Appendix 4: BRIDGE SUMMARY- KAPITI  
Site Specific Management Plan 003 - [SectorS 360-370-380]  
MacKays to Peka Peka Expressway

01 SEPTEMBER 2014 - CERTIFIED ISSUE - REV C

Proposed Kapiti exploded isometric

PROPOSED PLAN- KAPITI BRIDGE- 1:500@A3

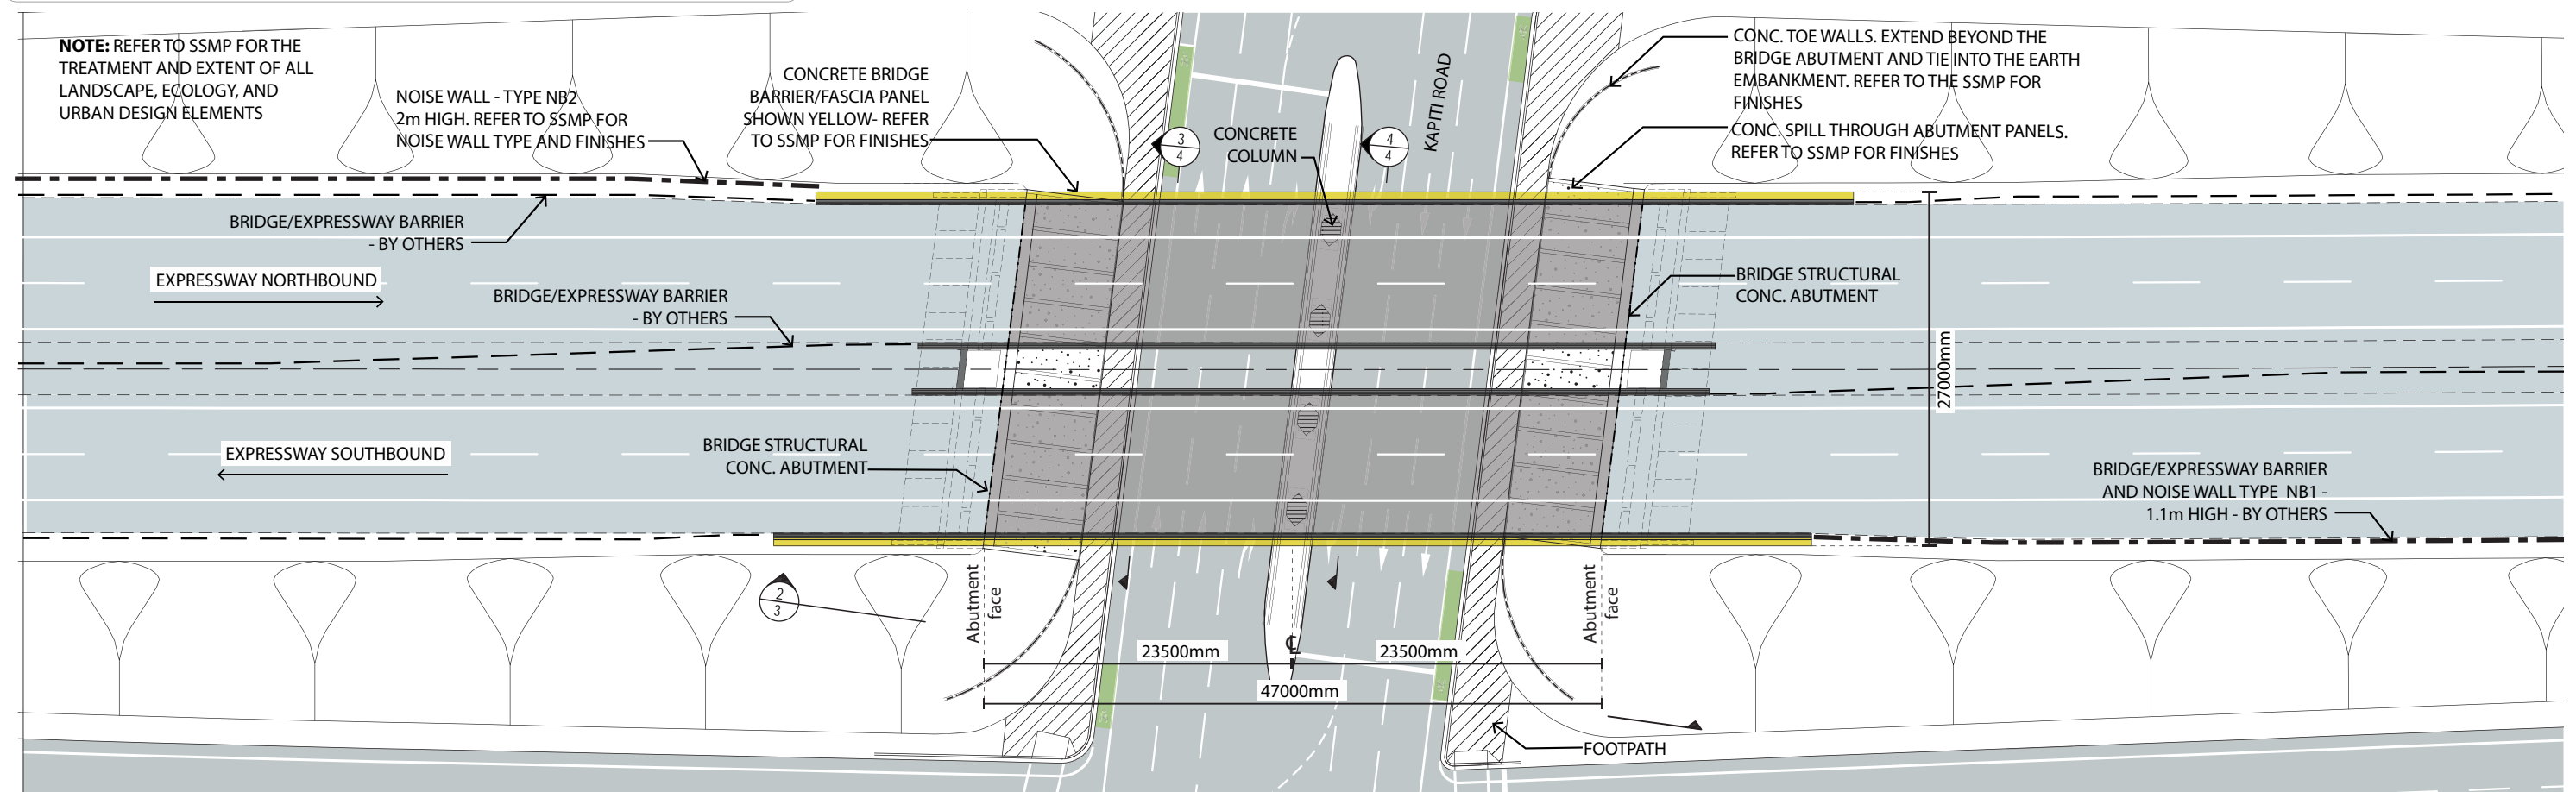
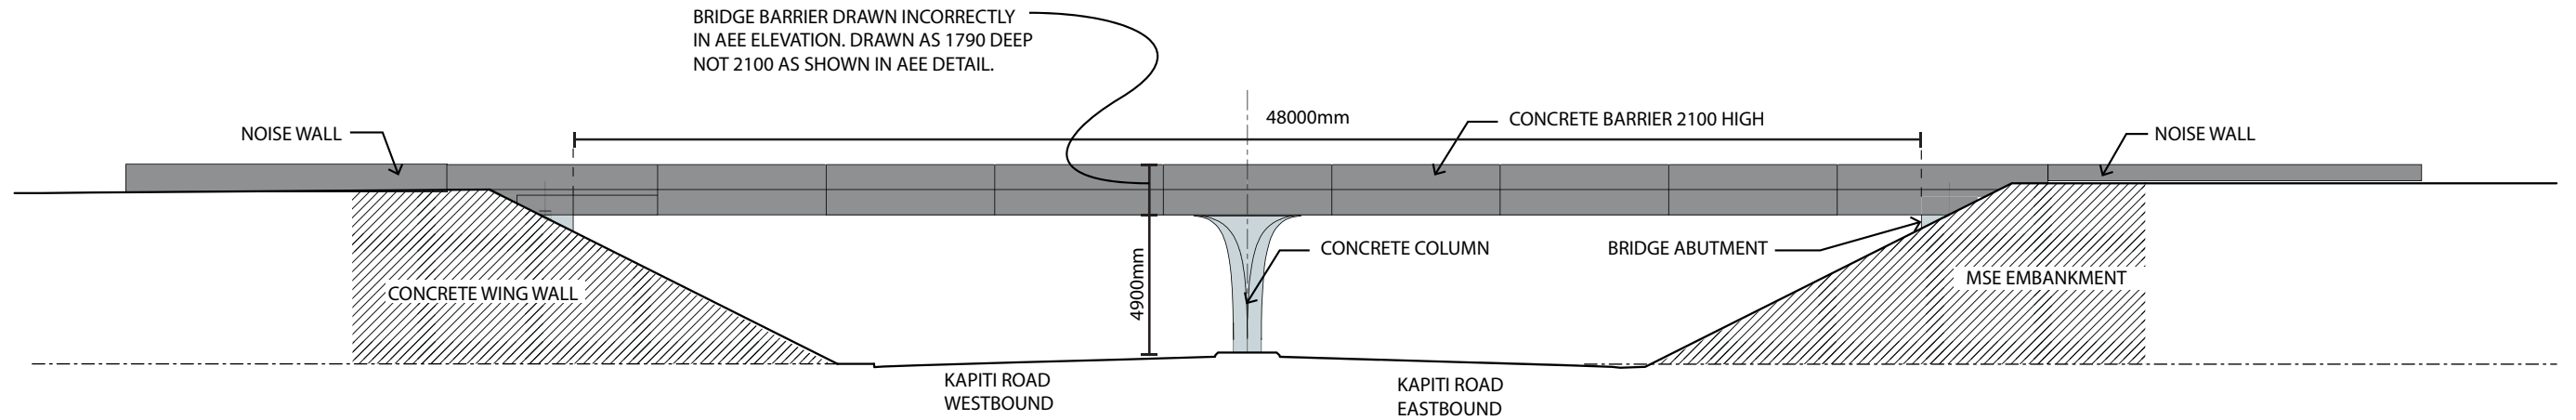
1. Further detail provided for abutment treatment
2. Further detail provided for pedestrian and cycle (treatment)
3. Columns moved in-board

1. Lack of info in AEE. Embankment developed to better integrate the level difference of the embankment and precast conc. spill through abutments.
2. Possible now that detail design of Kapiti Road has progressed
3. Simply supported structure requires platform to seat beam, and new arrangement helps resolve issues with bridge skew

2 PROPOSED ELEVATION - KAPITI BRIDGE EAST ELEVATION - 1:250@A3

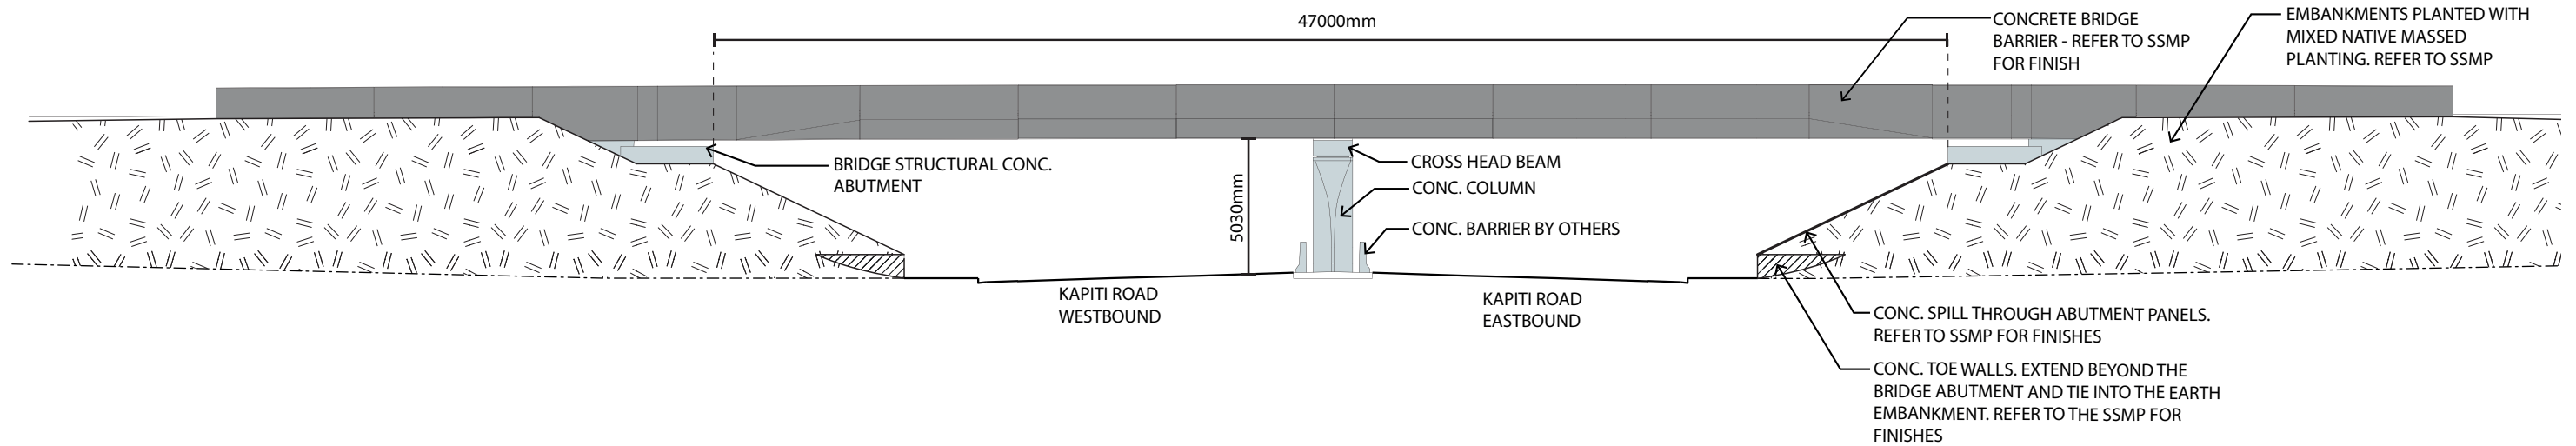
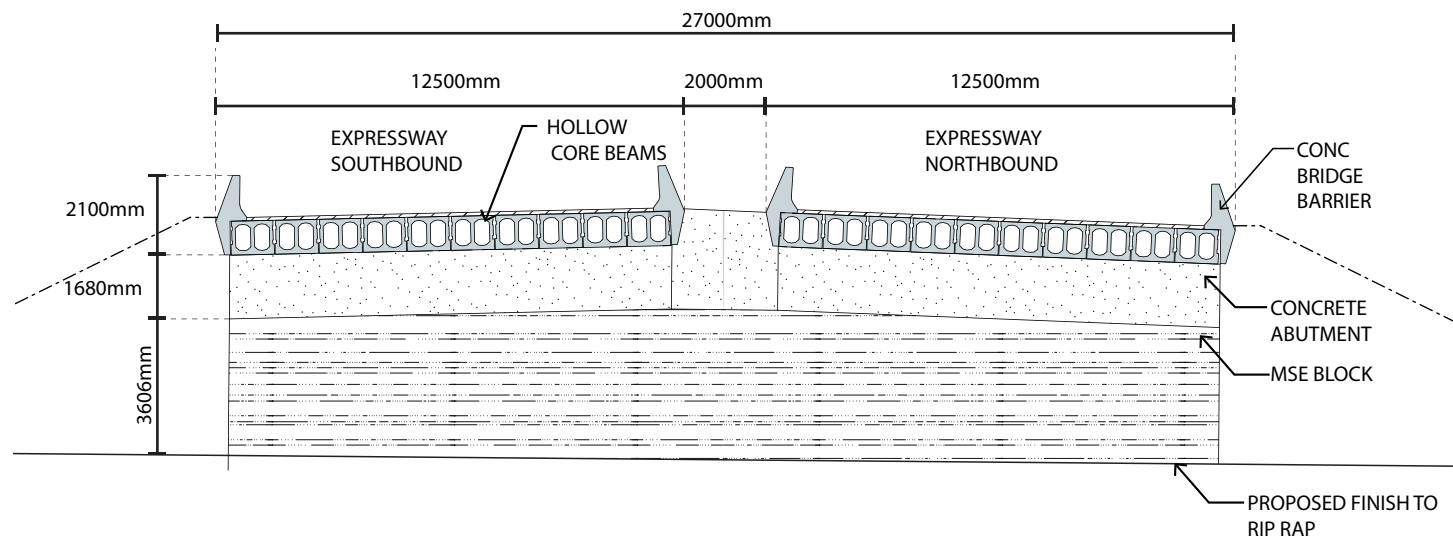
1. Column shape developed
2. Cross head lower by approx 200mm Change to simply supported system. Revised relationship between column, crosshead and barrier

3. Further detail provided for spill through abutment design and interface with embankments

1. Increased structural core based on geotech investigations carried out post AEE, while still providing the sculptural outer.
2. Simply supported structure requires platform to seat beam, and new arrangement helps resolve issues with bridge skew

3. Lack of info in AEE. Embankment developed to better integrate the level difference of the embankment and precast conc. spill through abutments.

3. PROPOSED SECTIONAL ELEVATION - KAPITI BRIDGE ABUTMENT (LOOKING SOUTH) - 1:200@A3

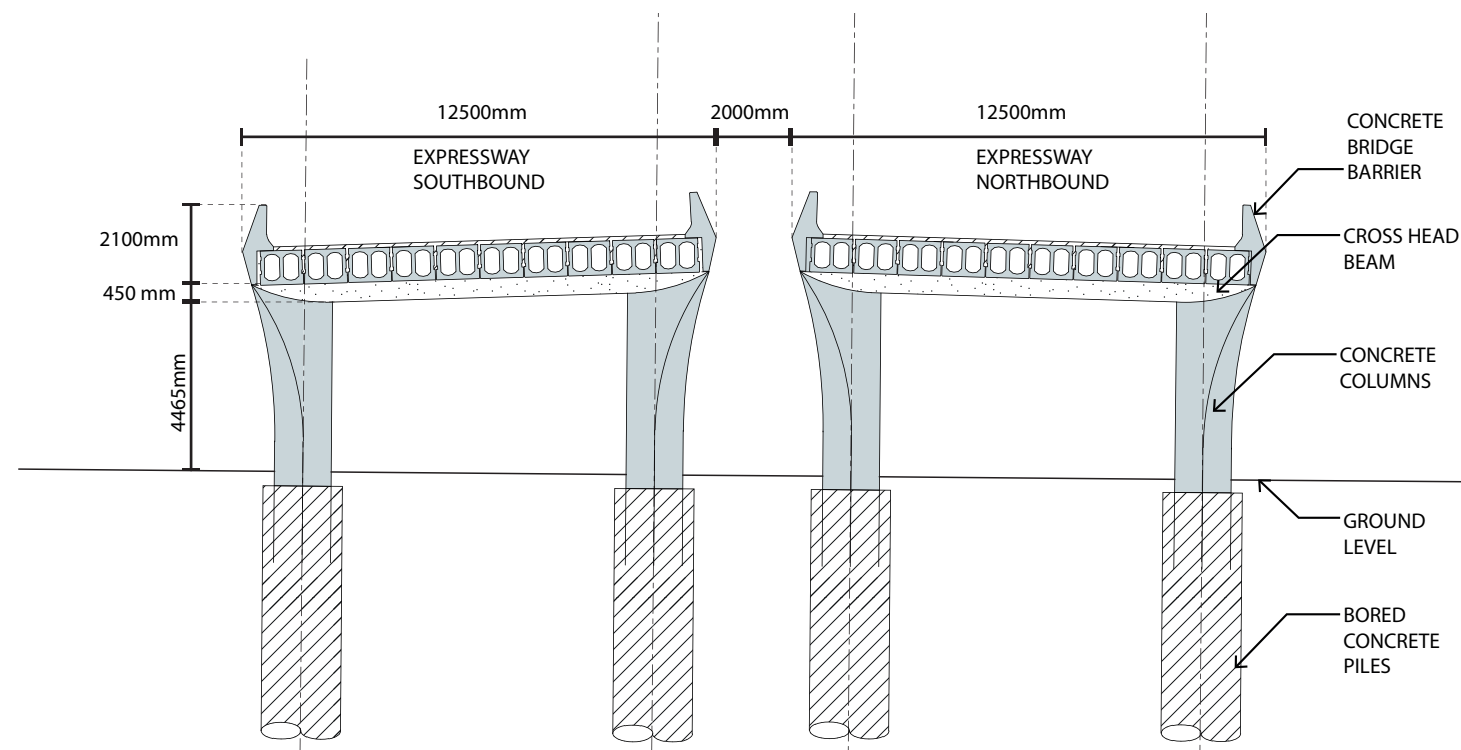
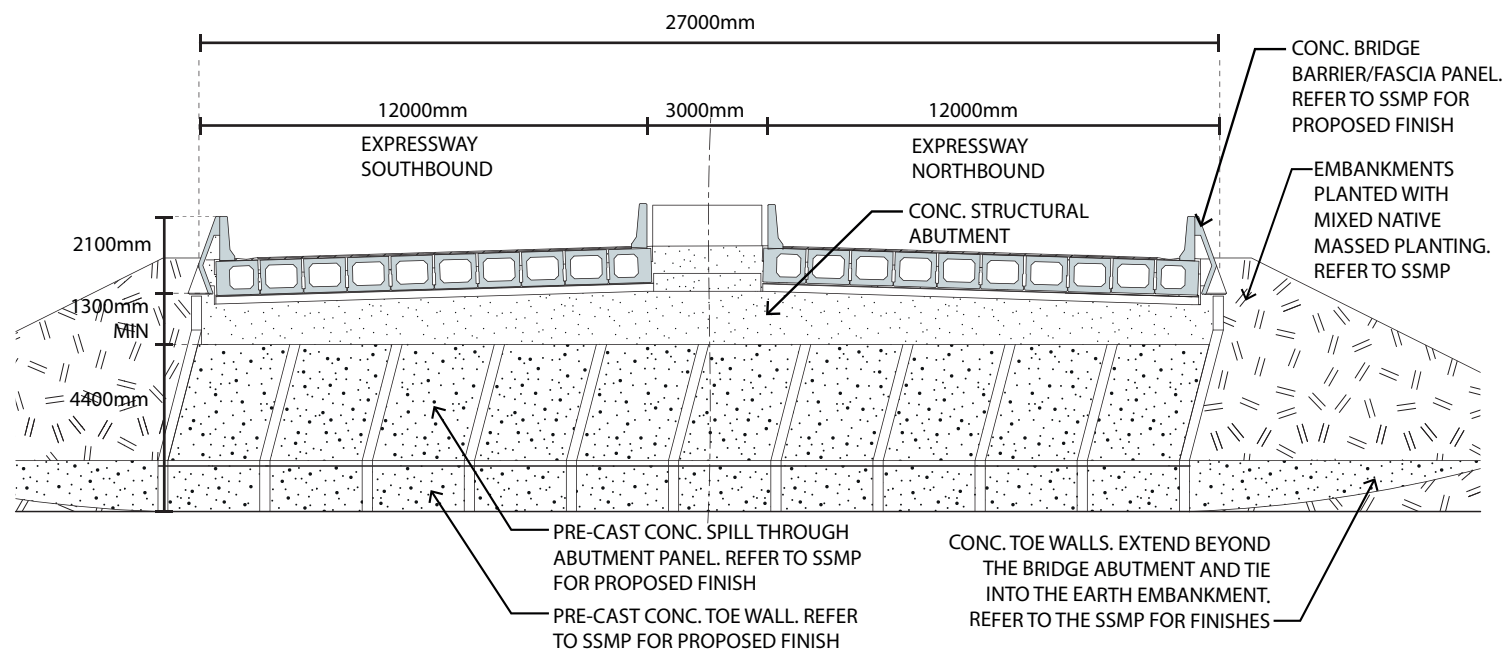
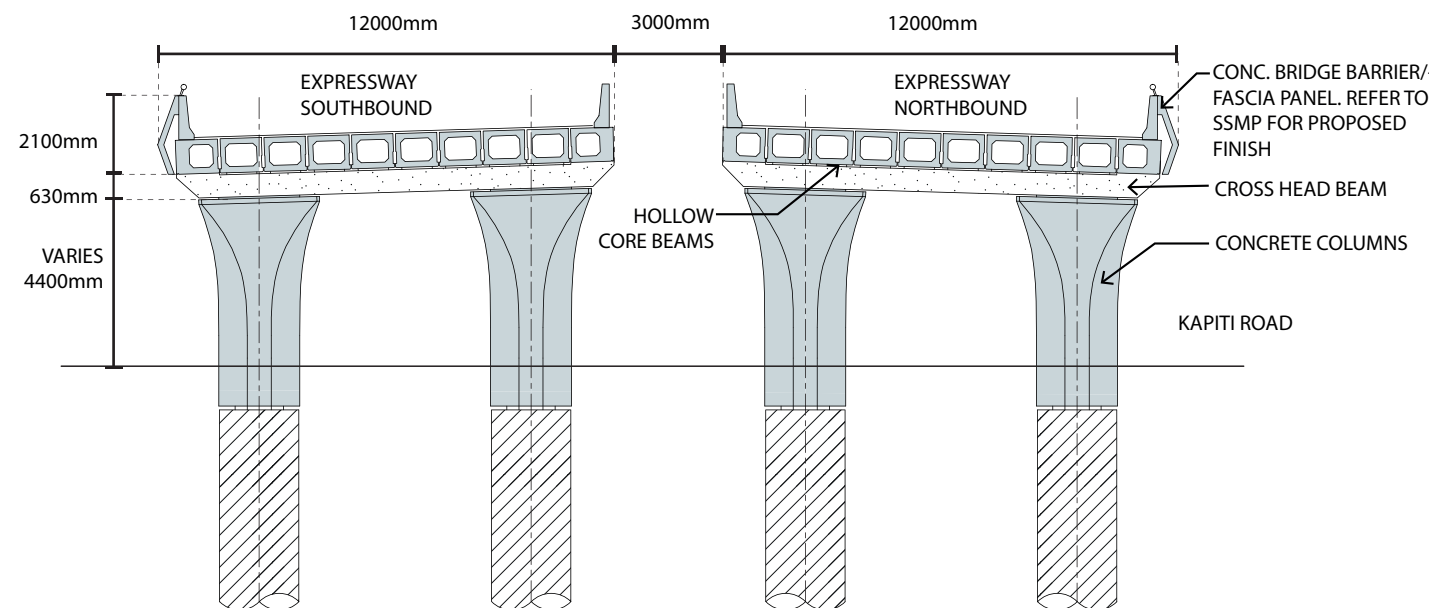
1. Column shape developed
2. Cross head lower by approx 200mm Change to simply supported system. Revised relationship between column, crosshead and barrier

3. Inside barriers straight profile
4. Further detail provided for the spill through abutment design

1. Increased structural core based on geotech investigations carried out post AEE, while still providing the sculptural outer.
2. Simply supported structure requires platform to seat beam, and new arrangement helps resolve issues with bridge skew

3. Increase width of light shaft.
4. Lack of information provided in AEE
